# **2020 Response Review of the Hood River Production Program**

Review of the Confederated Tribes of Warm Springs (CTWS) and Oregon Department of Fisheries and Wildlife (ODFW) response to the ISRP's review of the 2019 *Addendum to the 2008 Revised Master Plan for the Hood River Production Program (HRPP)*

**ISRP 2020-2**

**February 4, 2020**

Figure 1 (from the proponents' response). Total number of winter steelhead spawners in the Hood River (1992 – 2018).

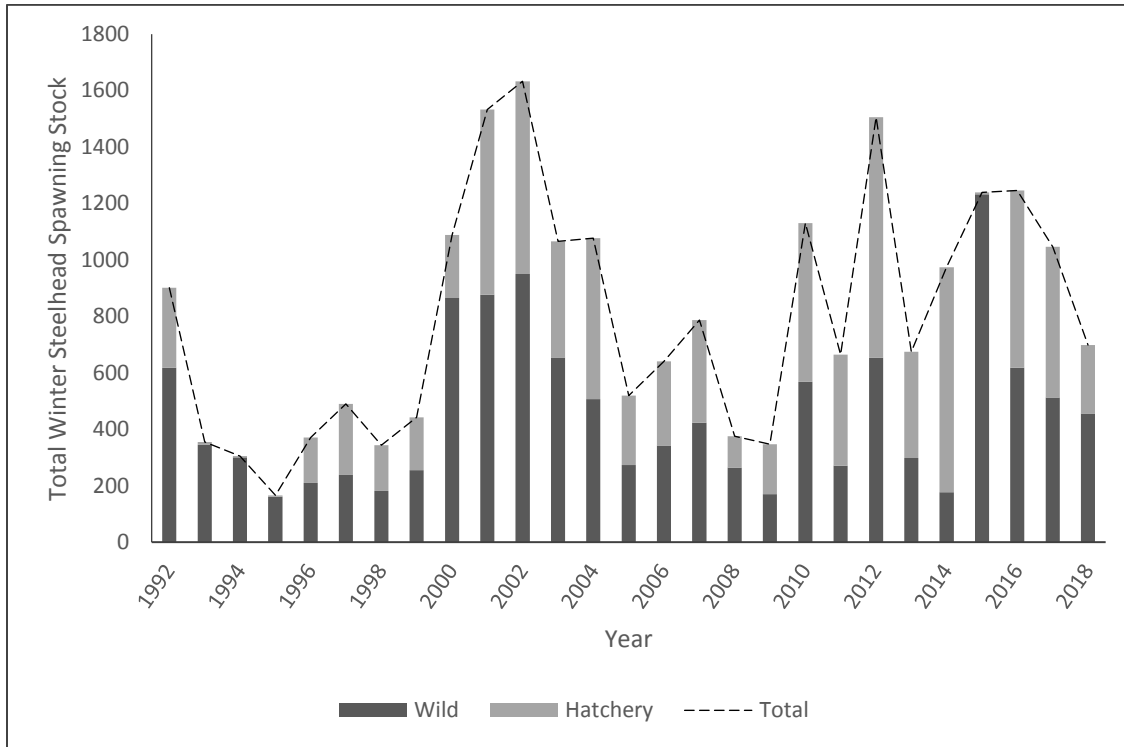
Despite its length and detail, the response does not adequately address ISRP concerns about the escapement target for natural origin winter steelhead. The proponents provide a new analysis in which parameters for a Beverton-Holt (BH) model are estimated from stock-recruitment data collected over the last 22 years (Figure 1). Strong density effects are evident during this time series with recruits-per-spawner falling below replacement (i.e.,  $R/S < 1$ ) in years with more than 700 fish spawning naturally in the subbasin (Figure 2). It is also evident in Figure 1 that the abundance of natural origin spawners (NOS) has not increased substantially since supplementation began in 2008. The quantitative target for NOS in the 2008 Master Plan (page 8) was to “achieve and maintain an average wild/natural-origin spawning population of 1,100 adult winter steelhead returning to the Hood River by 2019.” We commend the proponents for having formulated this quantitative objective in 2008, but the target has not been achieved. It now behooves them to re-evaluate the initial assumptions and the reasons for this lack of success, and to revise their initial objective accordingly.

Figure 2 (from the proponents' response). Hood River winter steelhead (1992 – 2013) recruits-per-spawner as a function of total available spawners.

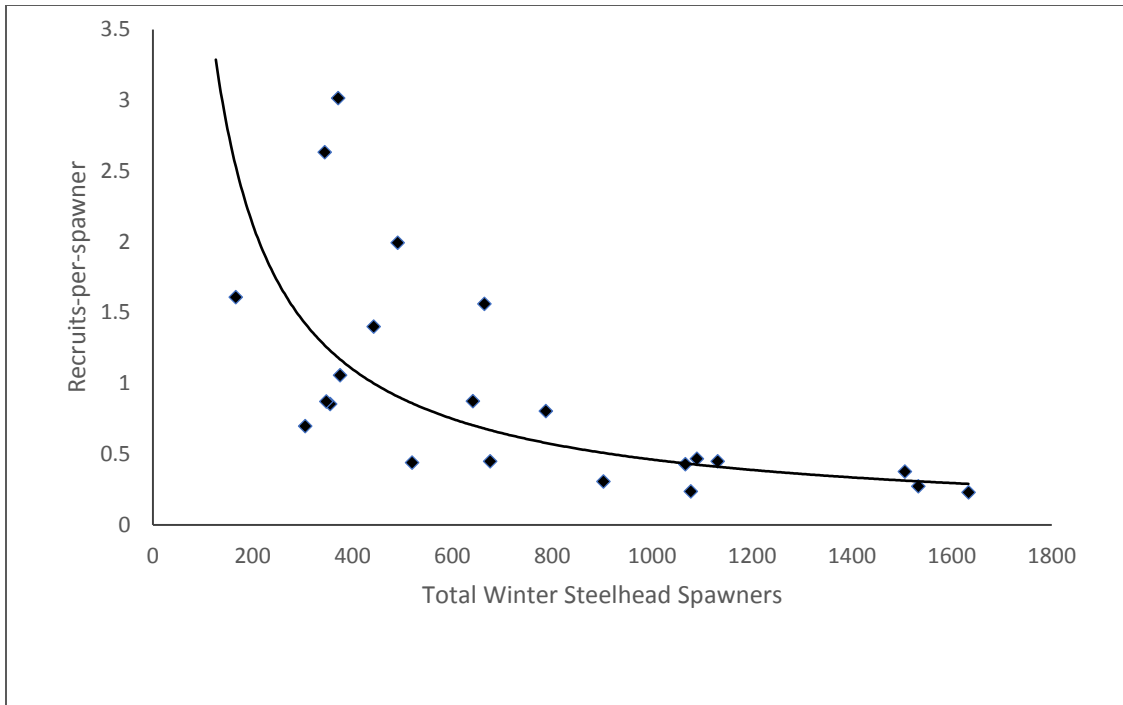
The ISRP has two specific concerns for how the provisional target of 1,100 NOS might be used inappropriately when managing returns of HOR. First, the goal of 1,100 NOS must not encourage managers to achieve a total escapement of 1,100 spawners by allowing a large escapement of HOS in the Hood River. The proponents note in their response that the ultimate goal is to exclude hatchery steelhead from the spawning grounds (i.e., pHOS = 0). It is important that fishery managers also recognize this goal and seek to limit pHOS via selective harvests, selective removal at weirs and ladders, and if need be, reduced hatchery production. The selective harvest target has not been achieved to date, even though sufficient HOR have been available for harvest. The inability to harvest HOR or remove them at traps and ladders has resulted in large total escapements (i.e., 698 to 1246) and highly variable pHOS (i.e., 1 to 82%) over the past 5 years (Addendum Table 10). This continuing high abundance of HOS is almost certainly reducing the productivity of NOS given the analysis shown in Figures 2 and 3.

The proponents also conclude that juvenile abundances (i.e., ranging from 78 to 1,828, 95% C.I. 48 to 2,238) and SAR values are typically too low for any model to characterize density effects. However, a low SAR value would not preclude a model from detecting density effects. Perhaps the proponents are simply pointing out that low levels of smolt production combined with low SAR values lead to "low" spawning escapements, but that conclusion begs the question of whether escapements are currently well below capacity. The ISRP's request to evaluate possible density effects on the productivity of spring Chinook is motivated by clear evidence of density effects on the productivity of the winter steelhead population. Data from the subbasin illustrate that recruits-per-spawner generally decreases when adult steelhead abundance exceeds ~400 fish (Figure 2).

Figure 3 (from the proponents' response). Density-dependent (Beverton-Holt) and density-independent stock-recruit models for Hood River winter steelhead (spawn years 1992 – 2013). Note the low number of steelhead recruits when the spawning stock exceeds ~800 fish.

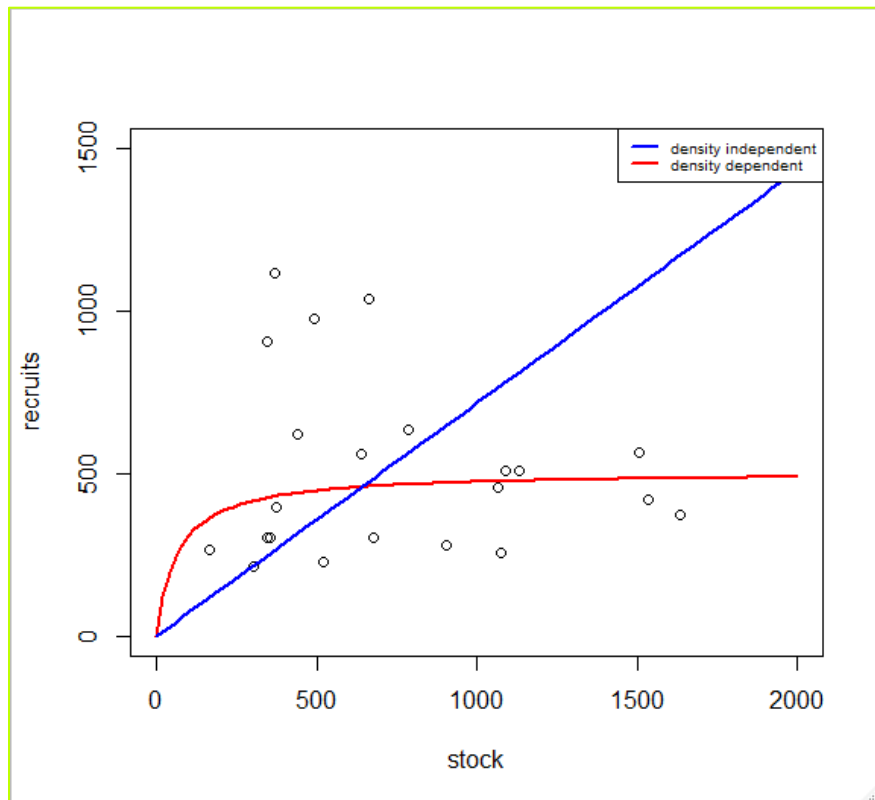
Second, the plot of recruitment data in Figure 3 suggests “overcompensation” in that a spawning stock between 300 and 800 spawners produced the 6 highest recruitments and higher average recruitment than spawning stocks exceeding 800 spawners. The ISRP is not aware of any reports of overcompensation occurring in other steelhead populations, and the apparent relationship may be a statistical artifact of this 22-year time series. However, overcompensation has been reported in some Columbia River Chinook salmon (see [ISAB 2015-1](#) and addendum). The main concern arising from overcompensation is that recruitment is expected to decline (rather than just level off) at high spawning abundance. HOS will exacerbate any overcompensation effects on NOS, so selective removal of hatchery steelhead in the fishery and at traps and ladders is needed to prevent the HOS escapement from causing the total escapement (i.e., HOS +NOS) to exceed the putative overcompensation threshold (i.e., ~800 spawners).
